Addendum No. 2

DATE: November 23, 2022
TO: ALL PLANHOLDERS OF THE GALVAN PARK RESTROOM REPLACEMENT PROJECT
FROM: YAT CHO – PROJECT ENGINEER
RE: CLARIFICATION

GALVAN PARK RESTROOM REPLACEMENT PROJECT

SITE PLAN
GALVAN PARK RESTROOM REPLACEMENT PROJECT

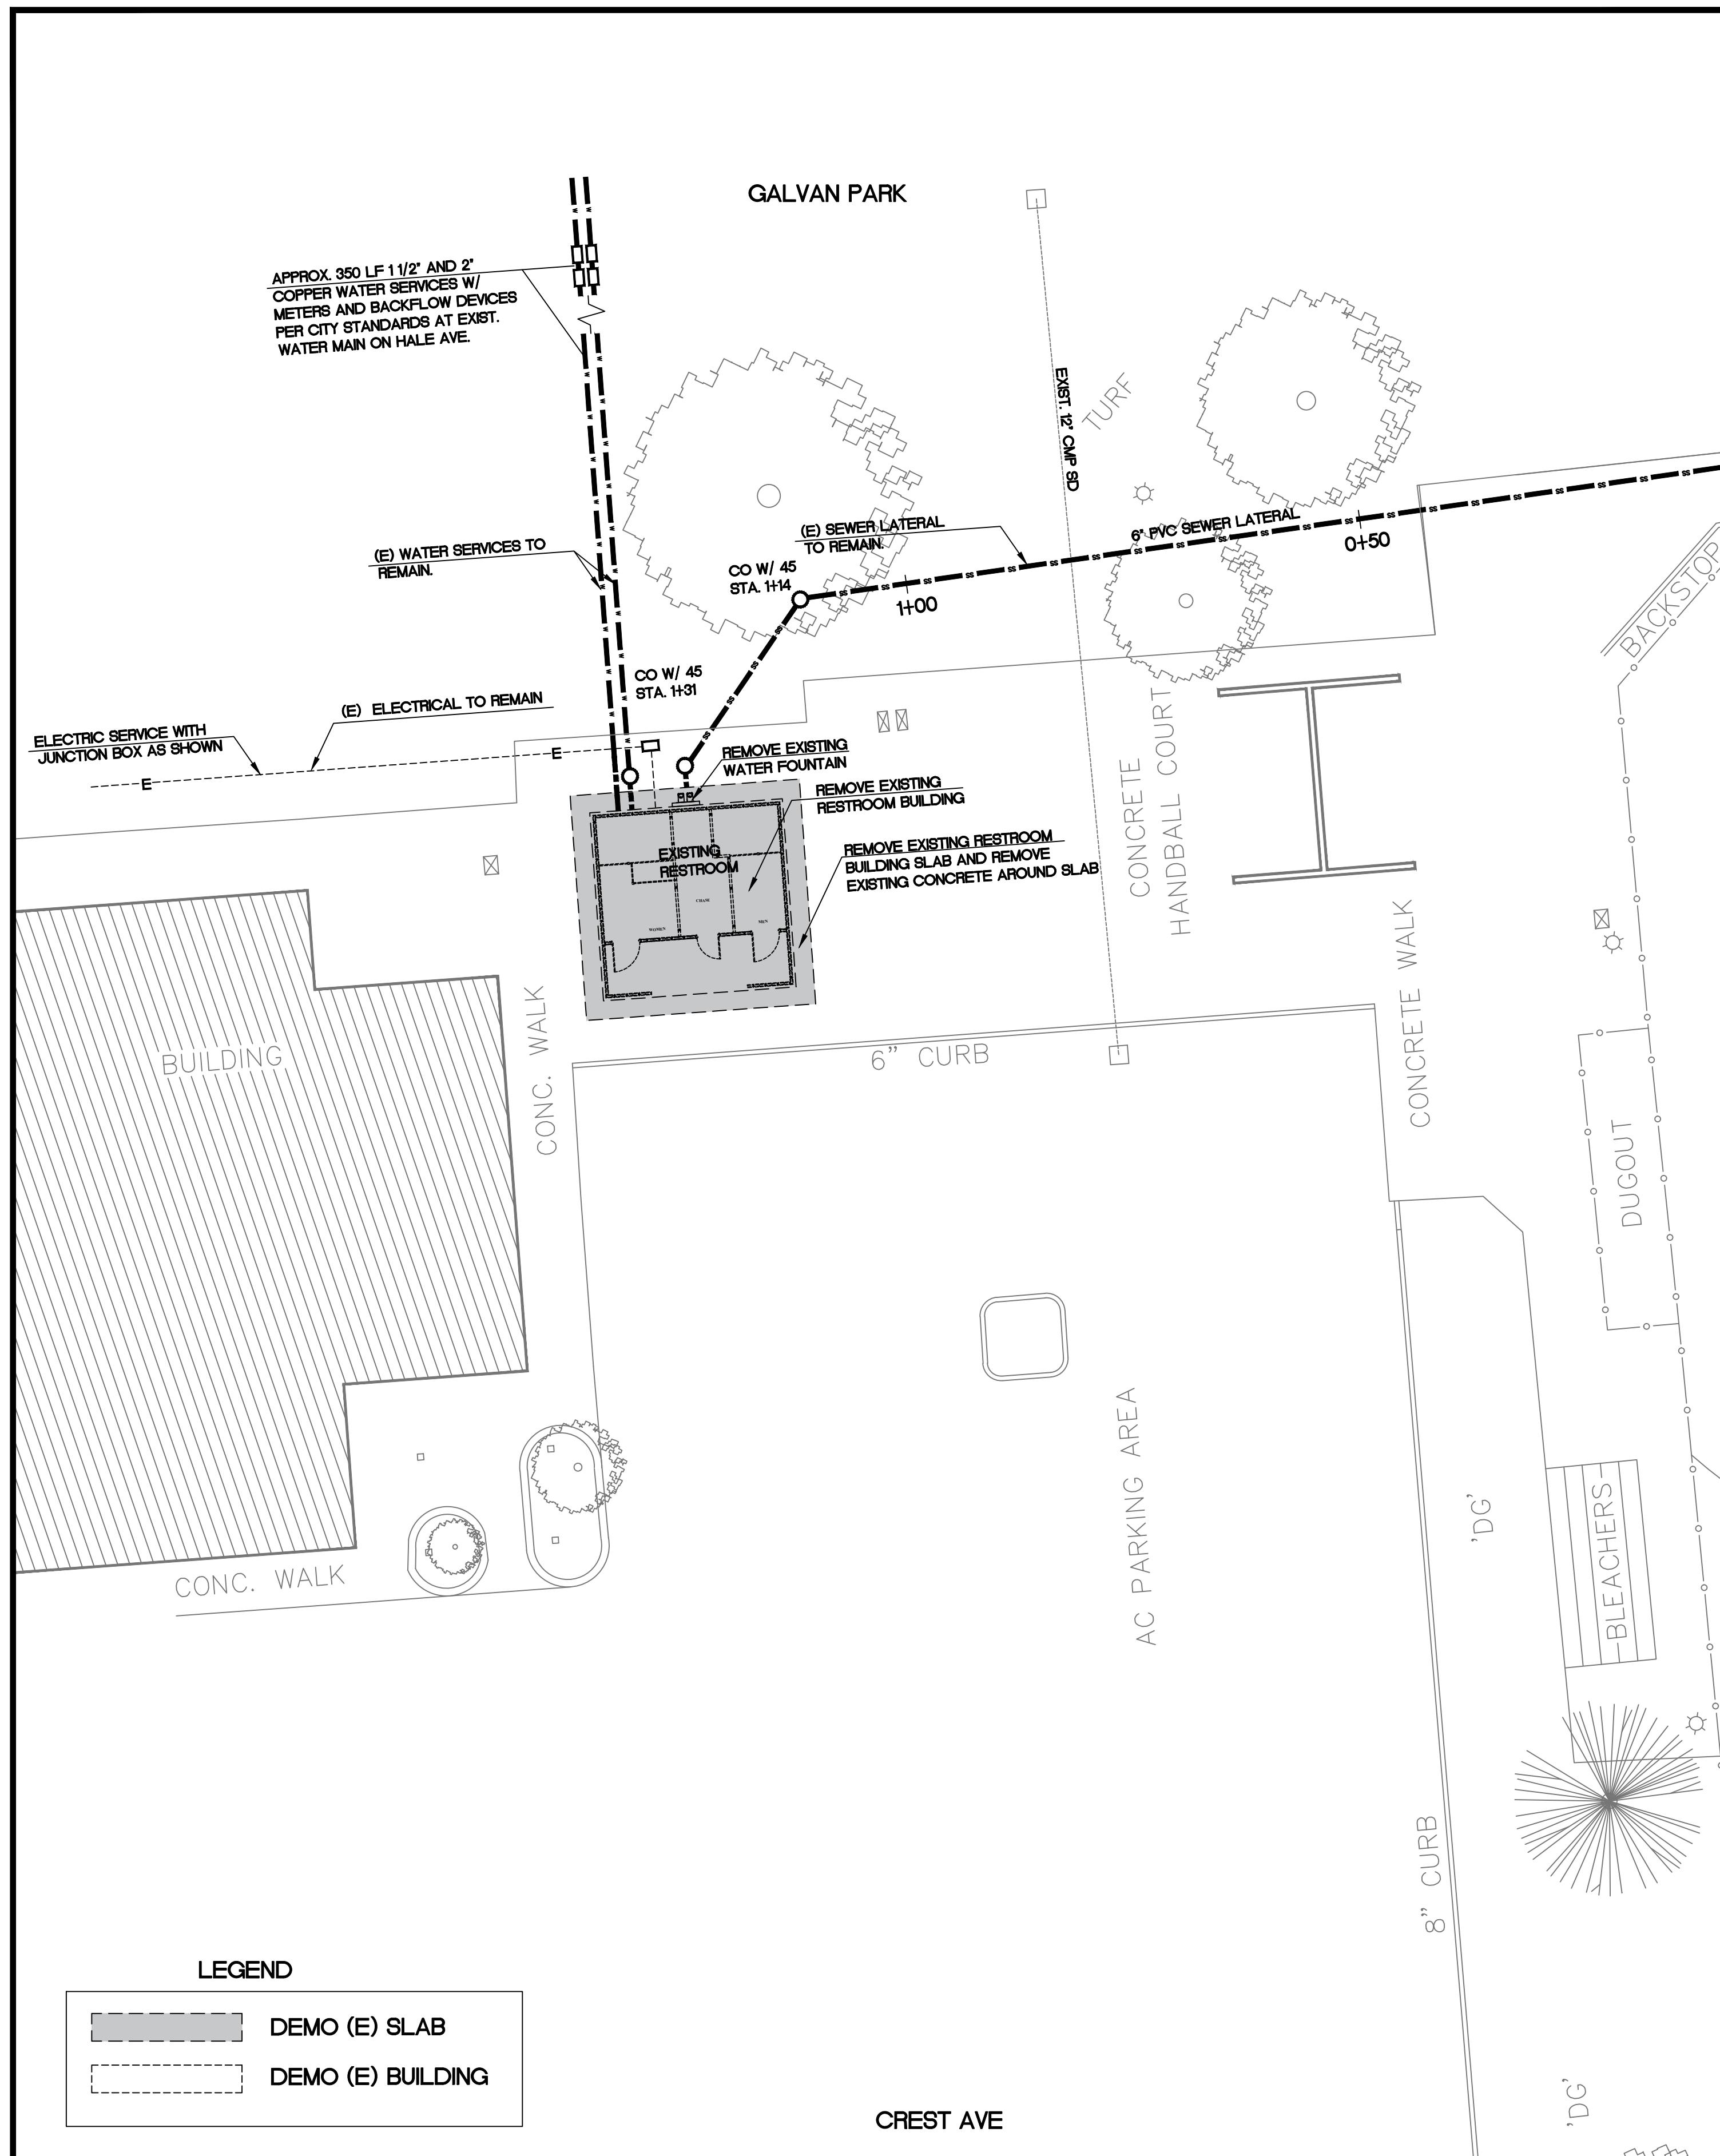
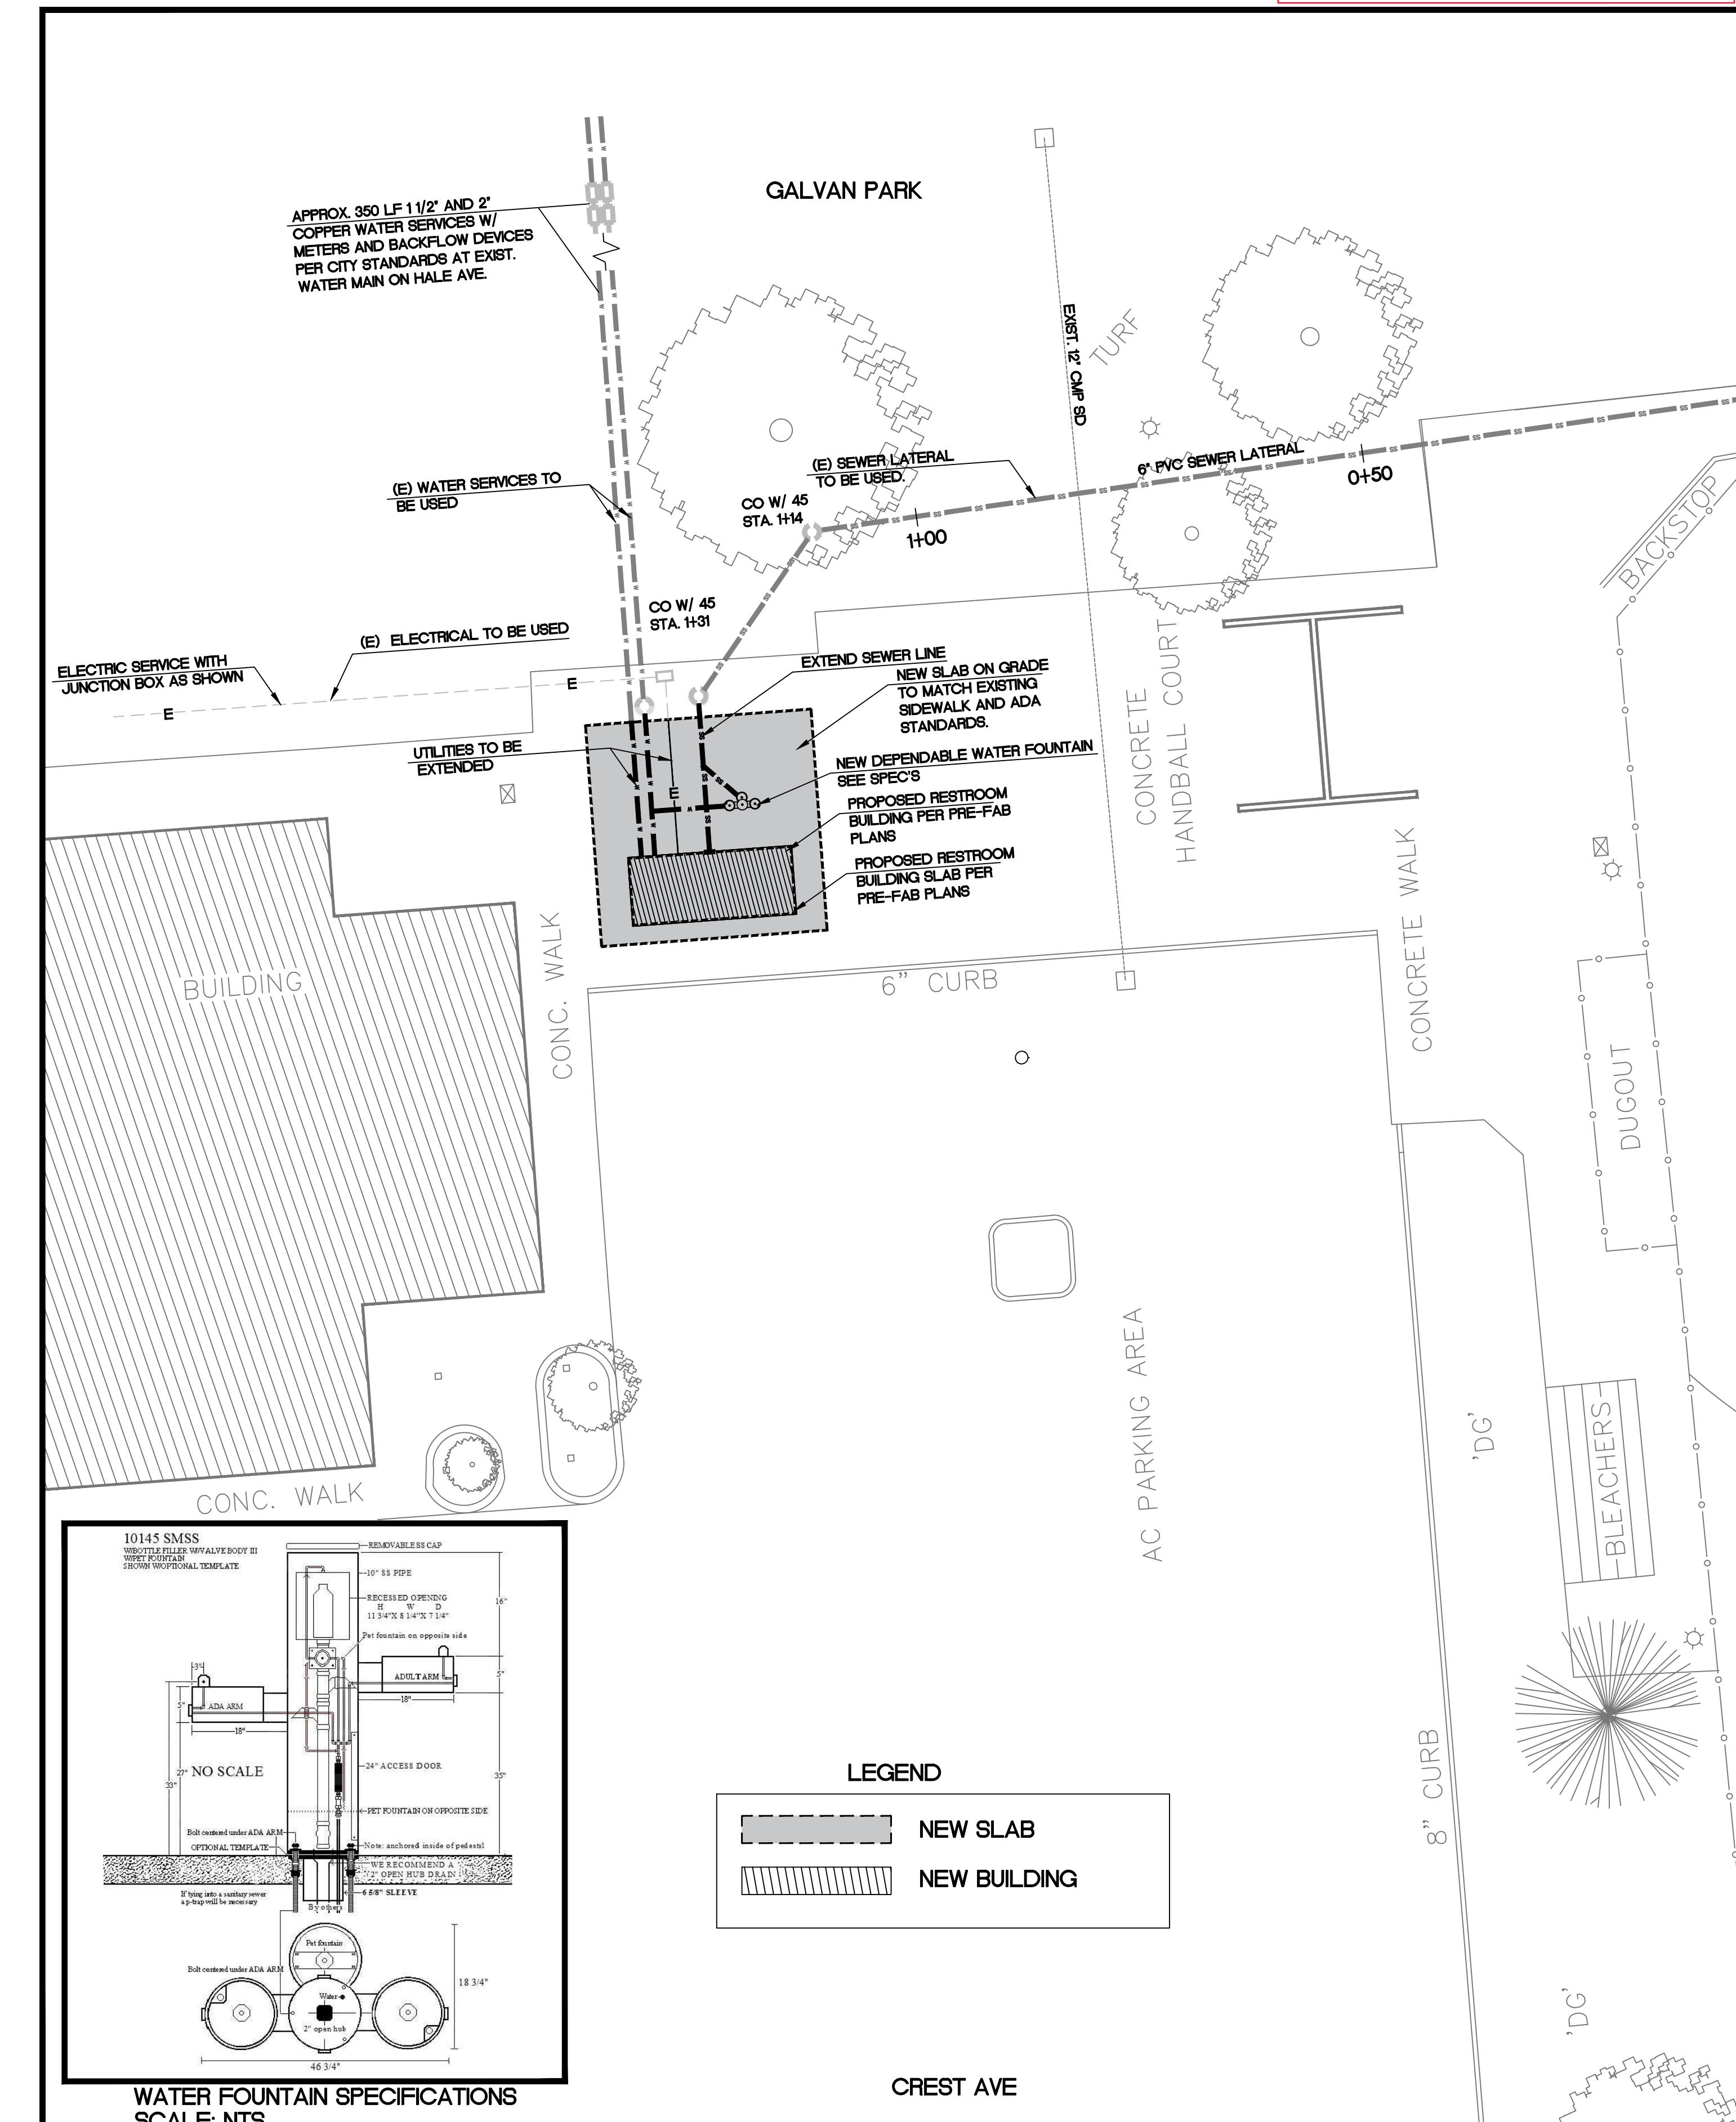
1. Replace Bid Schedule I – General with attached Bid Schedule I – General (Revised)
2. Replace Sheet 2 of plans with attached Sheet 2.
3. The project duration for the project is 60 calendar days.
4. The Engineer's Estimate is \$150,000.
5. Add Exeloo Restroom Quotation as Appendix C of the Project
